| Request | Modifications to DTC Standards |
| Project Name | NES Substation |

Downtown Code DRC Meeting of 08/02/2018

Site Plan

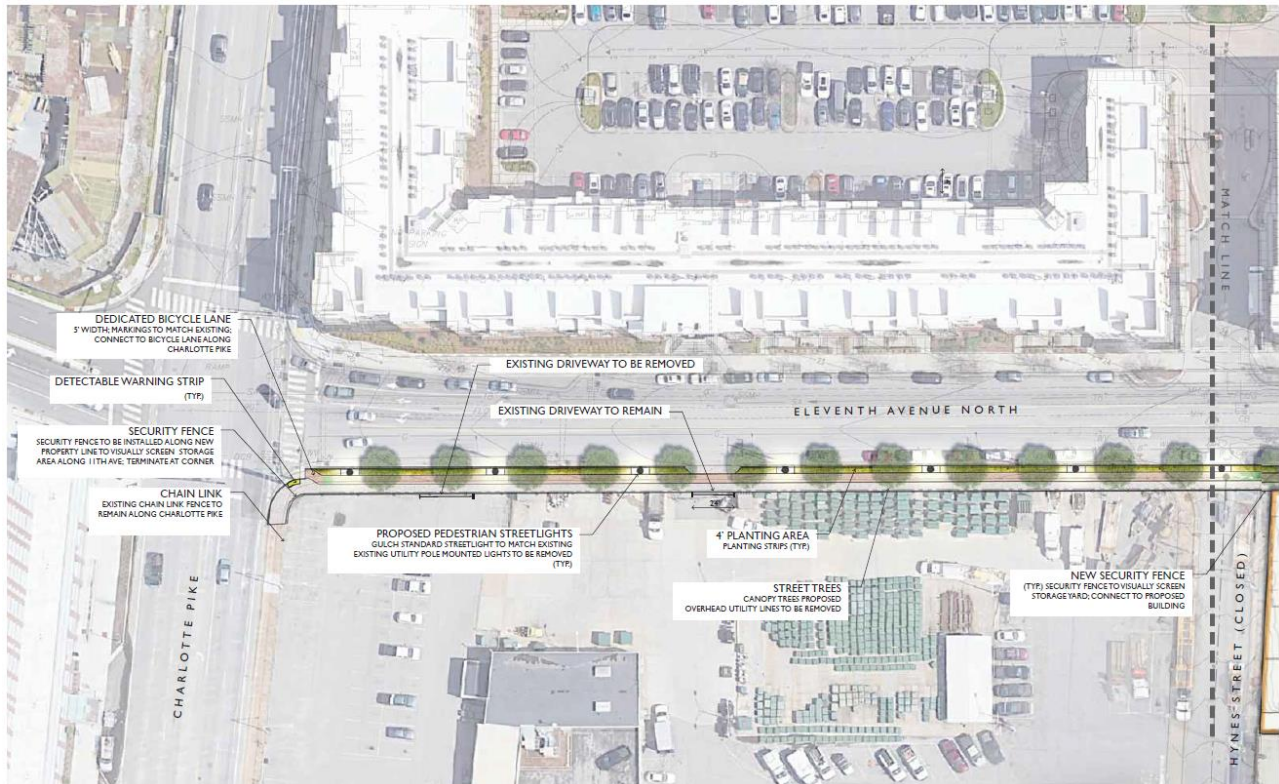
Several design elements are utilized to create a unique building. Use of overlapping metal panels creates a distinct architectural treatment along the full façade of the building that integrates the various façade components into a solid composition. Vertical elements introduce a secondary material that help to break up the massing of the building and avoid the “blank wall” effect. The spacing of elements, applied screening technique, and architectural lighting help create nuance and

visual interest along the street. These design elements contribute to generate a unique presence that contributes to the pedestrian character of the Gulch South subdistrict.

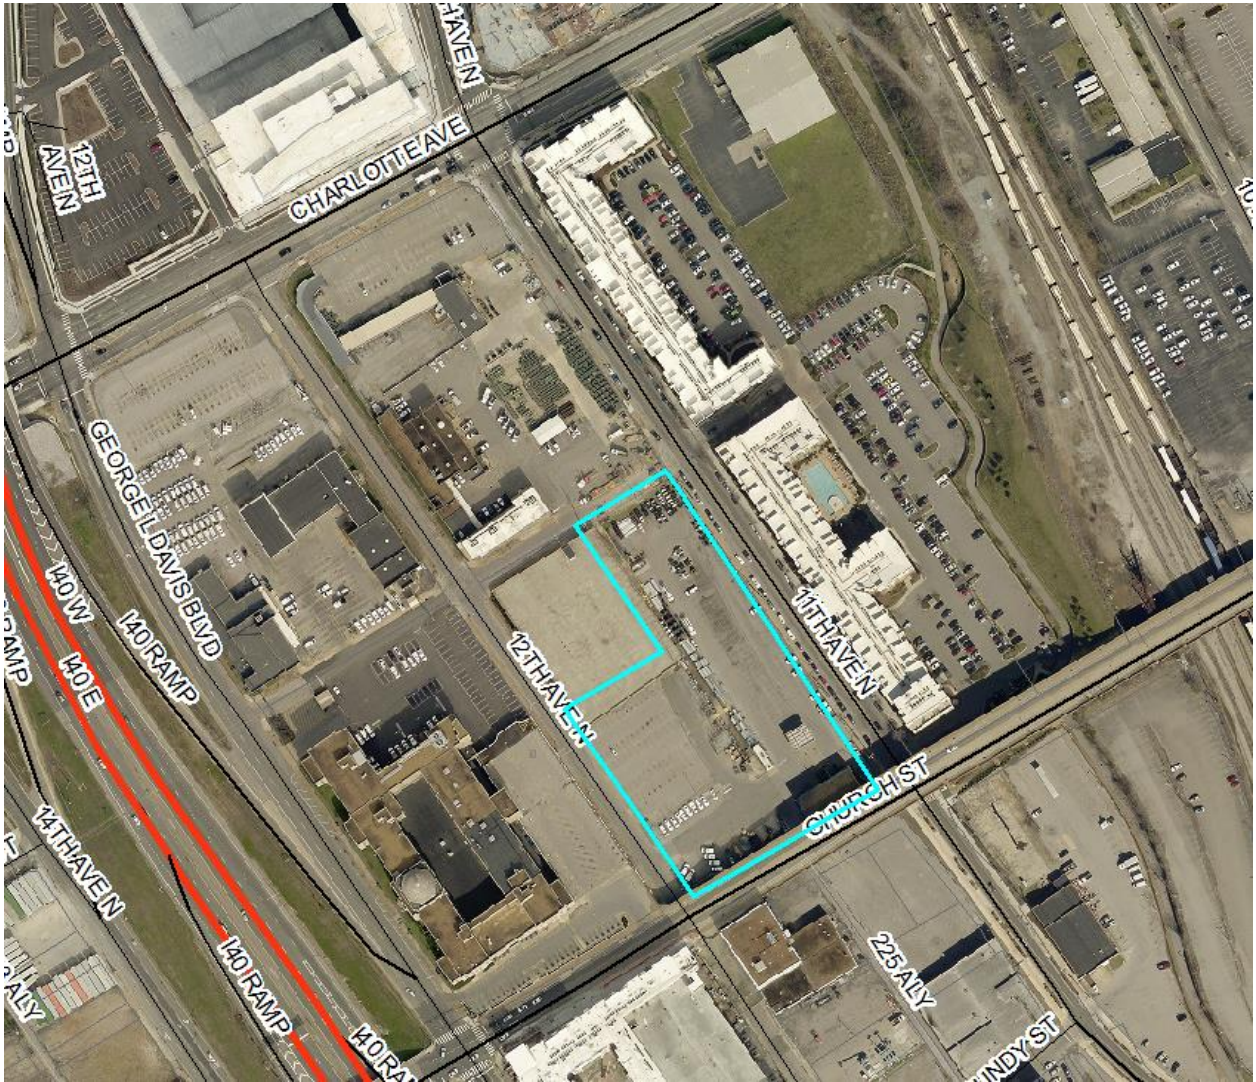
The proposed streetscape concept is requesting to eliminate the required 4ft frontage zone. In exchange for the modification, the applicant has proposed to offer the following offsite improvements along 11th Avenue from Church Street to Charlotte Avenue:

1. Bury the power lines underground.
2. Eliminate unnecessary curb cuts.
3. Install a privacy fence to visually screen existing storage areas.

The streetscape concept design for 11th Avenue North illustrates a complete street environment with sidewalks, dedicated bicycle zone, street trees, planting areas, on-street parking, and pedestrian elements including streetlights that tie into the existing Gulch standard to the south.

The proposed substation strives to meet the principles of the DTC to create and nurture the character of the Gulch South Subdistrict with an active and attractive street and streetscape. Given the inherent nature of the use of the building as a utility, modifications to standards are warranted. Staff recommends approval of the modifications with conditions:

1. Security fence shall meet the fencing standards of the DTC.

Existing Site Plan and Utilities

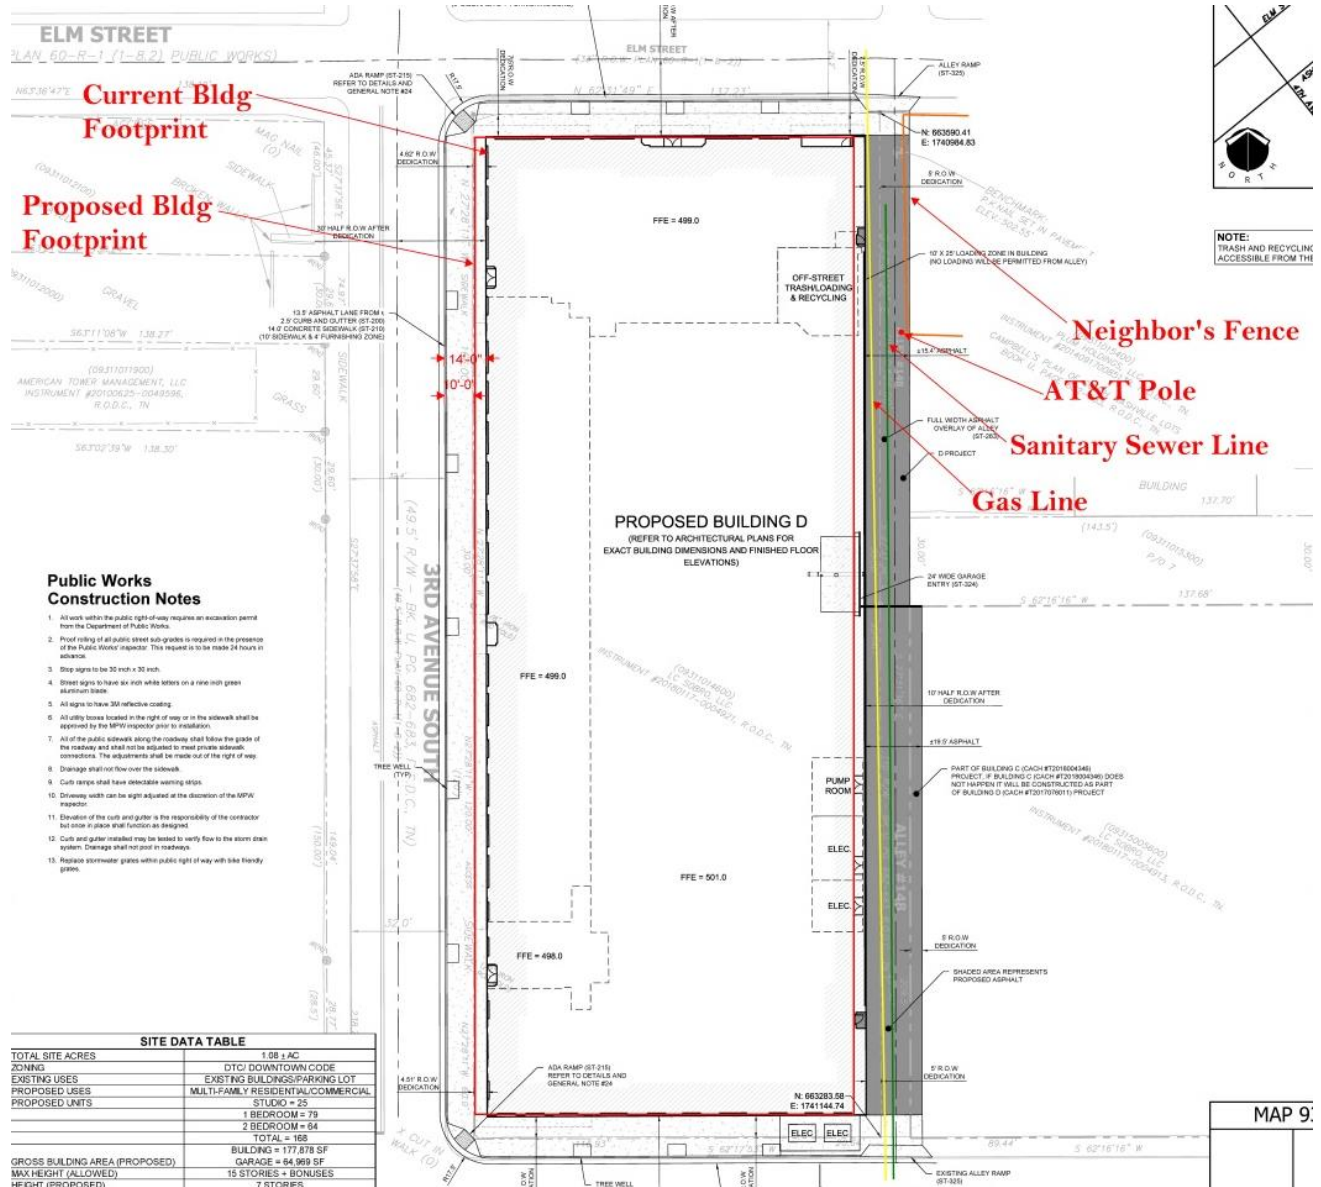
The applicant was initially proposing compliance with the MCSP, but during site work discovered utility conflicts in the alley, specifically a gas line that requires greater clearance from the building than what was proposed. The applicant explored the option of relocating the gas line with Piedmont Gas, but it was determined that this was not reasonably feasible due to the size of the gas line and utility conflicts in adjacent streets.

In order to provide the necessary clearance from the gas line, the applicant is proposing to move the building 4 feet closer to 3rd Avenue South. This moves the building into the ROW that they were proposing to dedicate in order to meet the MCSP requirements. Moving the building 4 feet closer to 3rd Avenue South will widen the alley at the north end from 15 feet to 19 feet and at the south end from 20 feet to 24 feet.

Proposed Site Plan

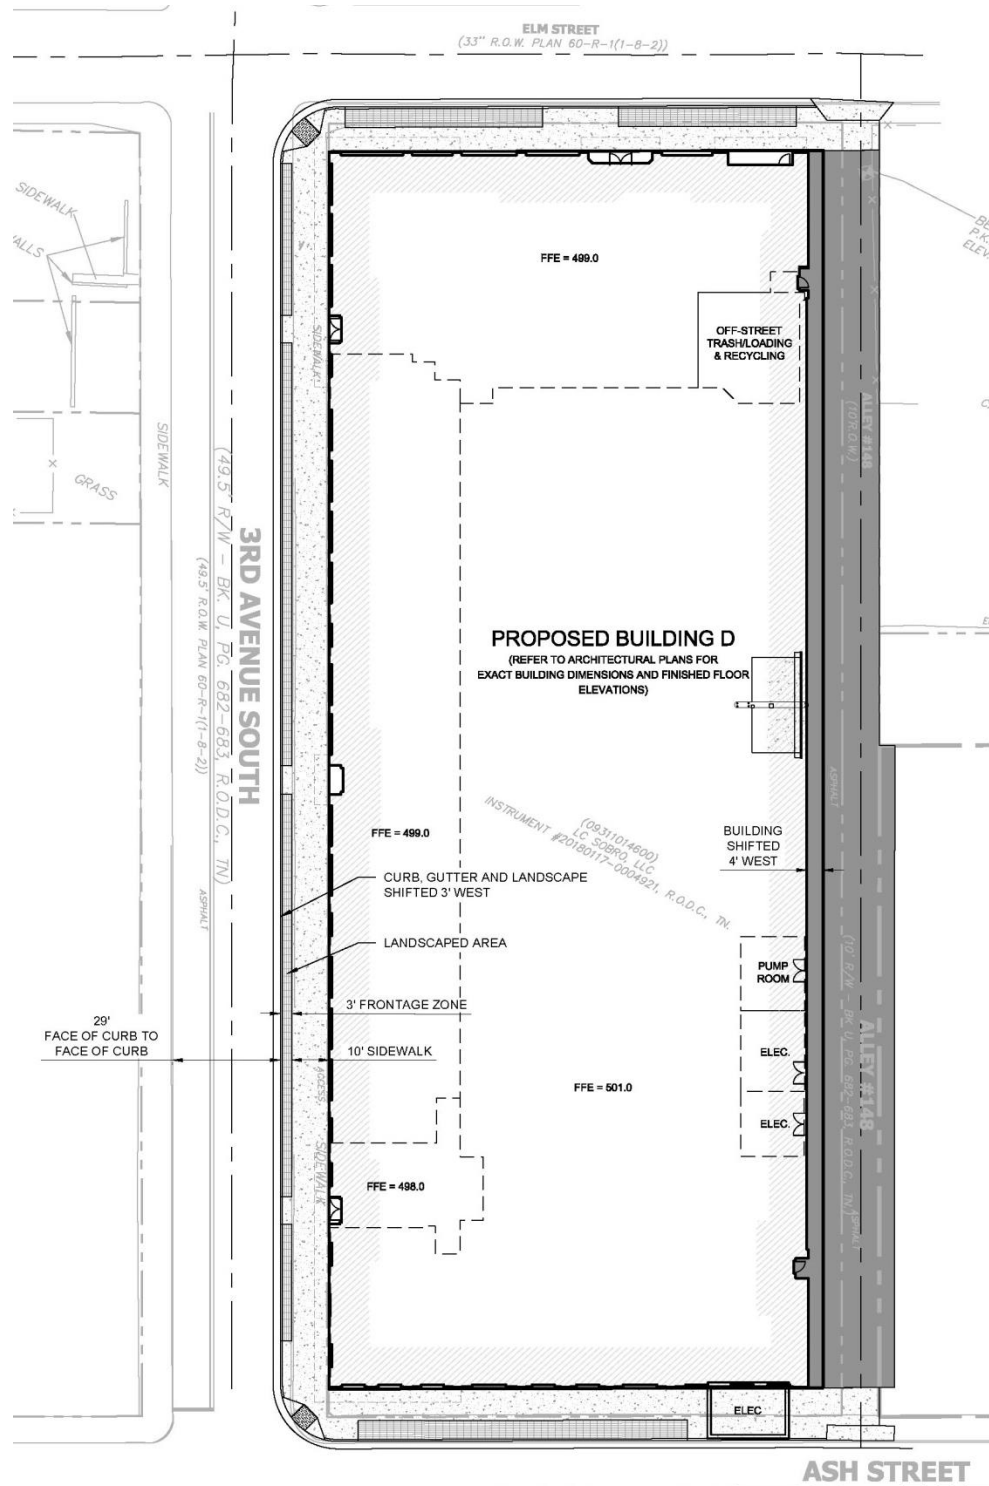
The applicant worked with Planning and Public Works on a recommended solution that would meet the intent of the MCSP while also providing the necessary clearance from the gas line. Planning and Public Works are recommending that the applicant move the full curb out 3 feet and provide a 10 foot sidewalk and 3 foot planting strip. Moving the full curb out 3 feet leaves 29 feet curb to curb, which would be sufficient for the future bike lanes that are planned in addition to the travel lanes.

Due to the location of duct banks under 3rd Ave S, street trees may need to be placed in above grade planters rather than in tree grates. This would have been the case prior to moving the building as well.

Staff recommends approval. The proposed modification meets the intent of the MCSP.
